Spectral Audio
Stockerstrasse 1
CH-6344 Meierskappel

Cyclus 3 modification on backlight

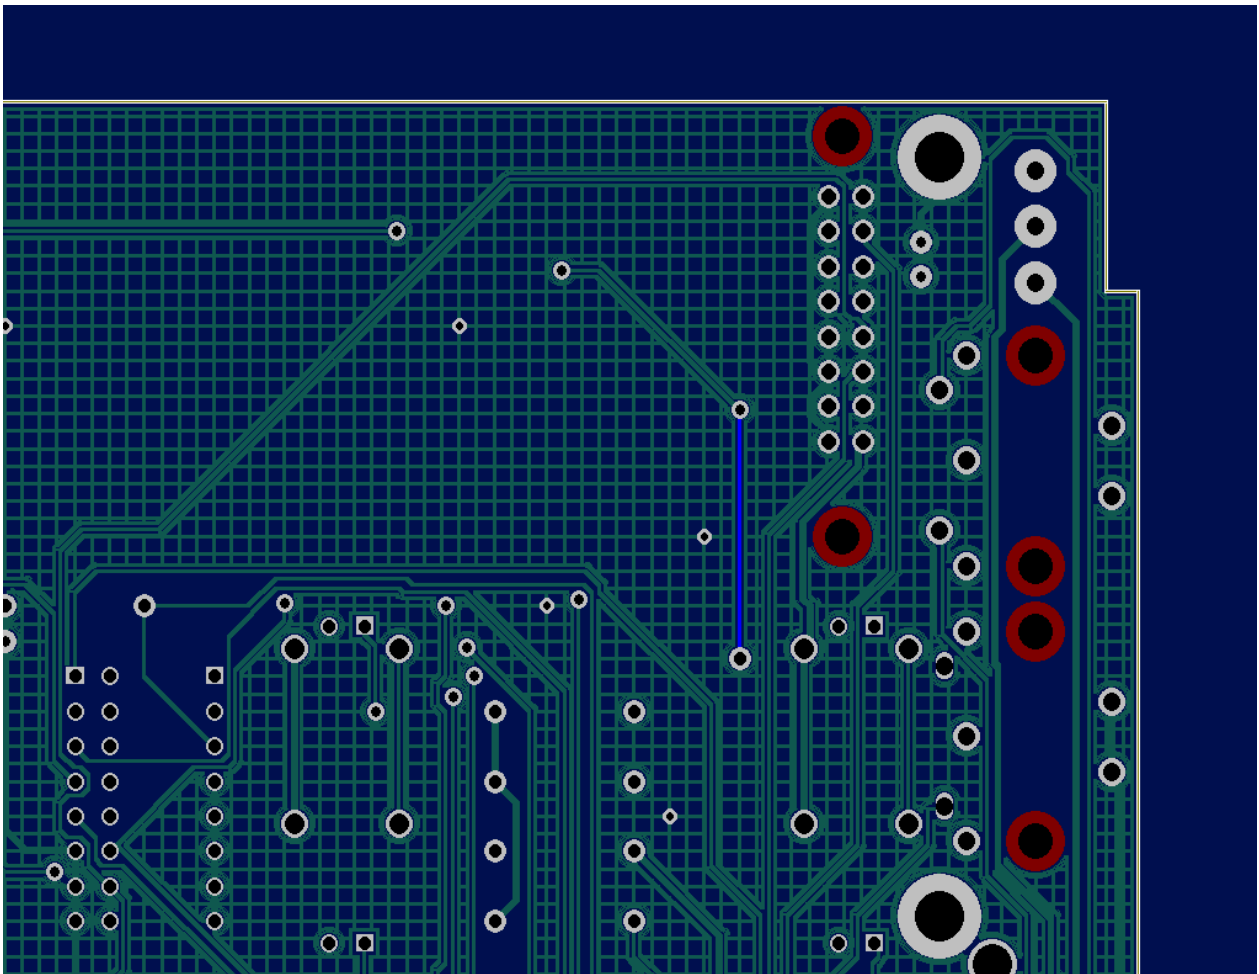
If you're planning to use the Cyclus 3 with battery operation (see docu "Portable Cyclus 3" you might want to reduce the power consumption even more. There is the possibility to turn off the backlight by removing R12 or cutting the blue track on backside:

You might want to use a switch.
